**DEPARTMENT OF WATER RESOURCES**

May 23, 2016

RE: Comments on Tentative National Pollutant Discharge Elimination System (NPDES)  
Permit No. CA 0059188, CI-6610, William E. Warne Power Plant

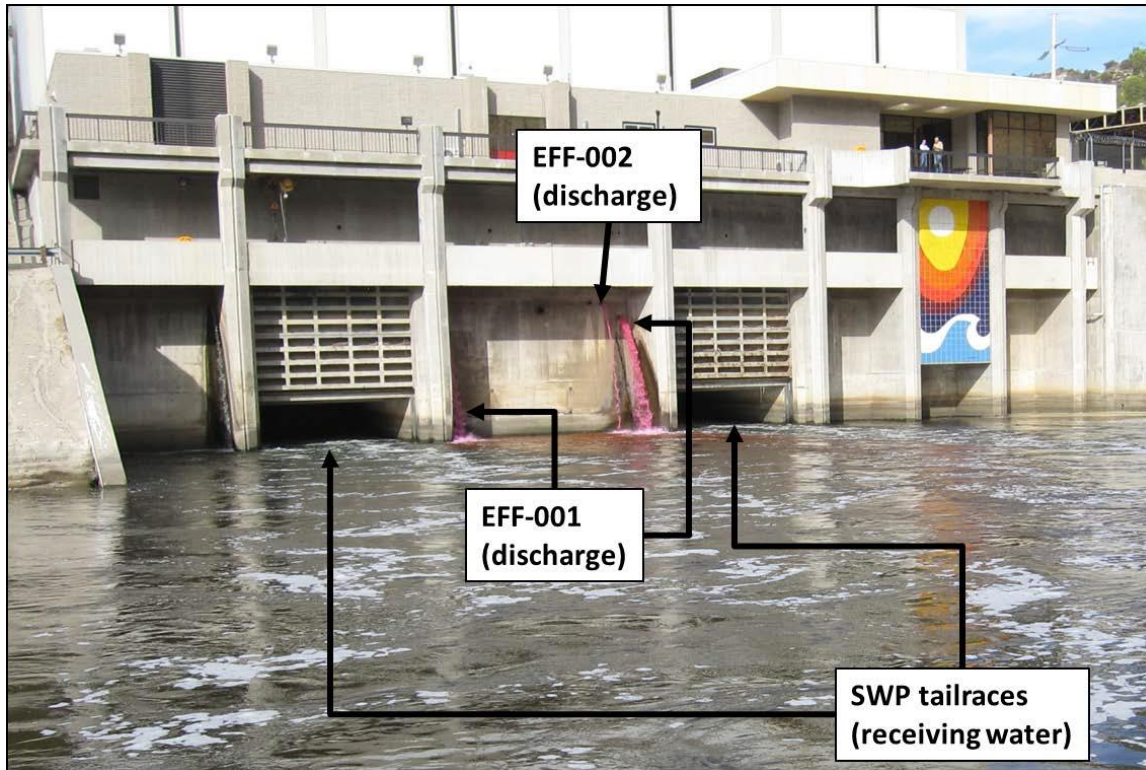
Because of the configuration of the WEWPP discharge, it is not necessary for the Basin Plan Objective to be met in the effluent in order to ensure that DO in the receiving water is not impacted. Specifically, after the point where the effluent is sampled for DO (for safety reasons, sampling occurs inside the building), the WEWPP effluent discharges approximately 8 feet above the water's surface resulting in significant aeration of the discharge before it reaches the water. Therefore, the discharge should be saturated with DO by the time it reaches the receiving water and will not adversely impact the receiving water DO levels.

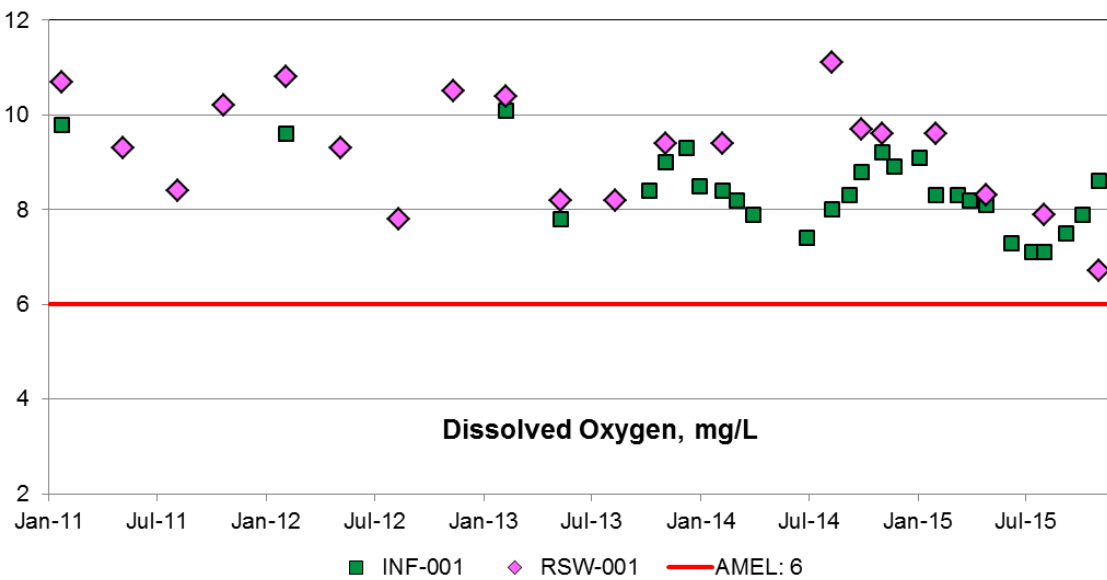
The following figure shows the discharge leaving the facility and entering the receiving water. While, both EFF-001 and EFF-002 are visibly mixing with oxygen, direct measurement of the DO in the effluent after leaving the facility is not possible due to safety and access concerns with the location of the discharge. It should be noted that the pink color of the discharge is because this photo was taken during the tracer study used to evaluate the mixing zone and available dilution.

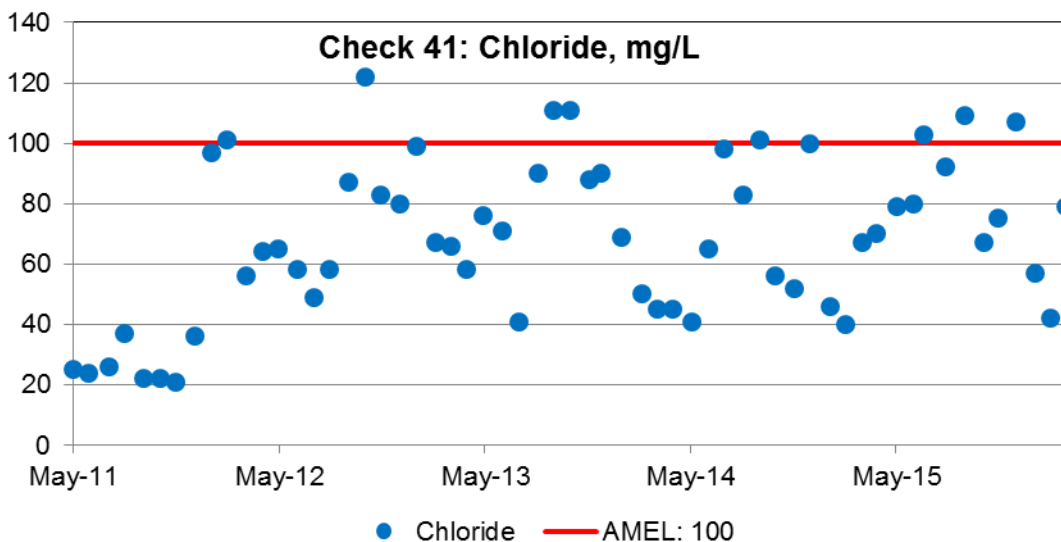
Chloride data was reviewed for a point in the State Water Project approximately 15 miles upstream of the WEWPP (i.e., Check 41, located just before the bifurcation of the CA Aqueduct into the East and West branches). While this is a significant distance upstream, as shown below- if the chloride were to persist over this distance, it is likely that the WEWPP would have difficulty complying with the proposed effluent limitation of 100 mg/L.

Imposing effluent limits for chloride is unlikely to result in any measurable change or improvement in water quality while increasing the regulatory burden and resulting in violations with penalties for the discharger. Therefore, DWR requests that effluent limits for chloride be removed from the permit.
